## Product Change Notice (PCN)

PCN Number: PCN-0456188R-01

Product(s) Affected: PJ-030DH-SMT-TR

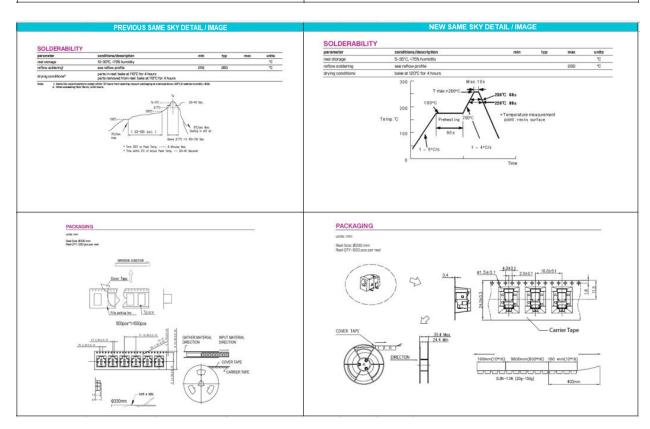
Description of Change: New Factory Location. Product re-engineered for improved manufacturability and production yield. See image below for reference and check the Same Sky website for updated drawing after 10/20/2024. Cosmetic differences may be visible but will notaffect the form fit and function of the product.

housing PPA UL94V-0) black housing PAIDT	
center pin brass tin center pin copper terminal 1 brass t=0.3 silver terminal 2 phosphorus bronze terminal 3 brass t=0.4 silver terminal 3 brass t=0.4 silver terminal 3 brass tell nickel housing PPA (UL94V-0) black   Decenter pin copper terminal 1 brass terminal 2 copper terminal 3 brass terminal 3 brass tell nickel shield cold roll housing PPA (UL94V-0) black	
terminal 1 brass t= 0.3 silver  terminal 2 phosphorus bronze terminal 3 brass t= 0.4 silver shield stainless steel nickel housing PPA UL94V-0) black  terminal 3 brass t= 0.4 silver shield stainless steel nickel housing PPA 10194V-0) black	IAL PLATING/COLO
terminal 2 phosphorus bronze t=0.3 silver terminal 3 brass t=0.4 silver terminal 3 brass steel nickel housing PPA UL94V-0) black terminal 3 brass shield cold roll housing PAIOT	nickel
terminal 3 brass t=0.4 silver shield stainless steel nickel housing PPA UL94V-0) black  terminal 2 cupper terminal 3 brass shield cold rol housing PPA UL94V-0) black	silver over nick

shield stainless steel nickel housing PPA JUL94V-0) black shield cold roll housing PA10T	alloy silver over nick
housing PPA JUL94V-0) black housing PAIDT	silver over nick

- Ø3.5	led steel nickel
	UL94V-0) black
MATING PLUG MATING Jack Insertion Depth <mark>: 6.5mm</mark> Jack Insertion C
